City of Palm Springs

MEMORANDUM

Date: March 25, 2013
To: AAC Members
From: Glenn Mlaker, AICP – Assistant Planner 
Subject: 3.3616 MAA – O'Reilly Automotive Store - Restudy

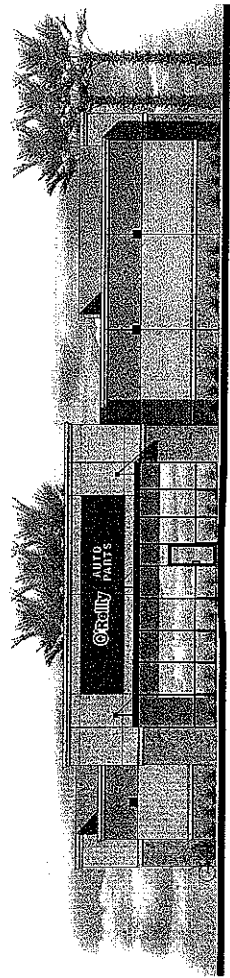
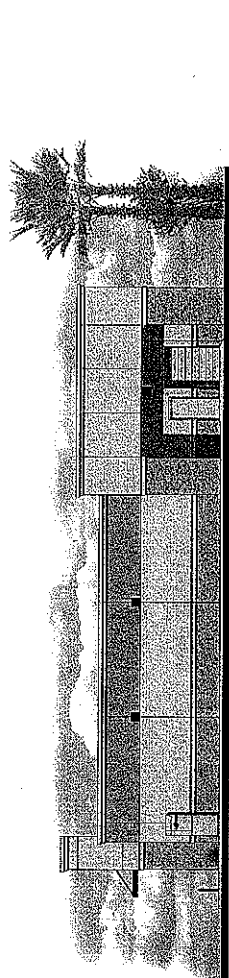
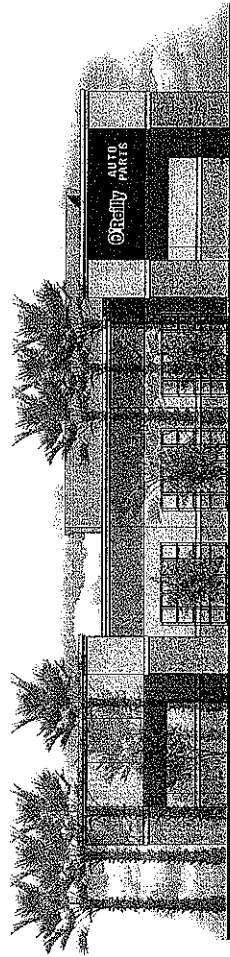
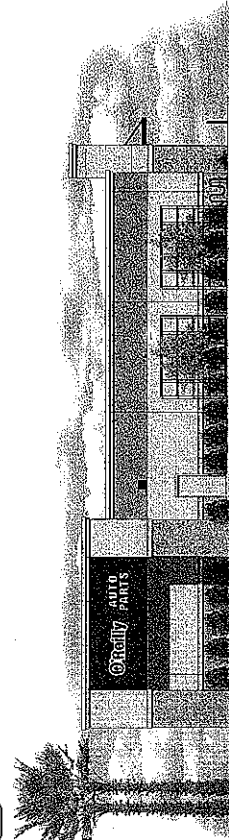
- 4. Increased articulation on the north and east building elevations.*
Revised elevations include the use of two separate stucco colors; colored split face block similar to other materials in the shopping center; the use of a tubular steel arbors placed on the east and north building elevation; and increased banding, scoring and other building articulations.

7. *Seek alternate to painting of split face block.*

Revised elevations include the use of colored split face block to match existing block in the shopping center.

The proposed building colors include "Softer Tan" for the main stucco body; "Latte" for accent stucco; "Dark Ivy" for the store front glass / metal frame system; and colored split face block to match the shopping center. The proposed steel arbors are to be painted a dark brown color.

1 PLANTING PLAN
 L-1 SCALE: 1" = 20'-0"

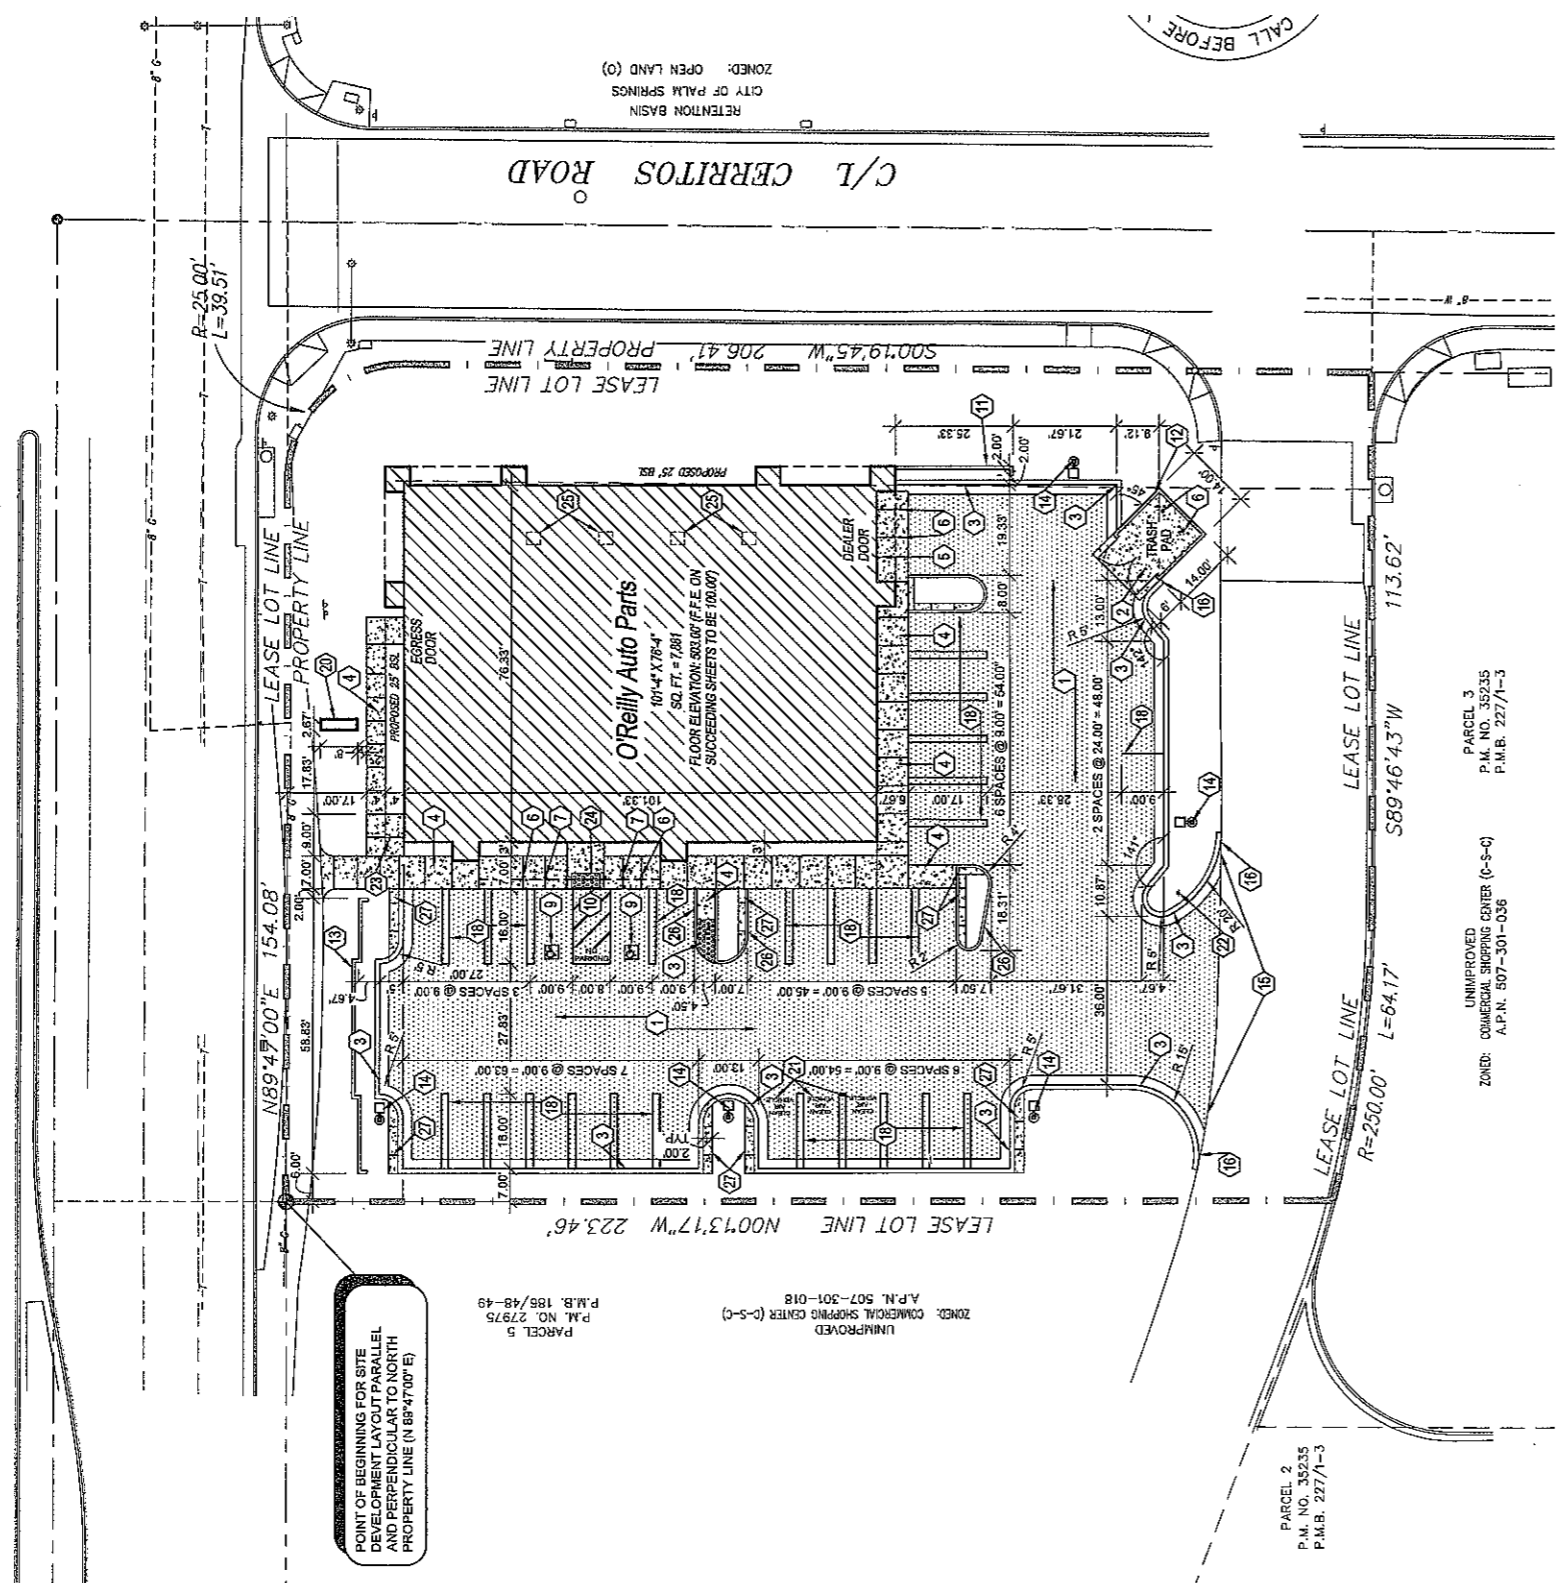
- 1. Landscape plan to be enhanced with use of varying plant heights, types and quantities; include types of ground cover.*
Applicant has stated that landscape plan has been revised.

8. *Increase landscaping around trash service area.*

Enhanced plantings around the trash area are shown.
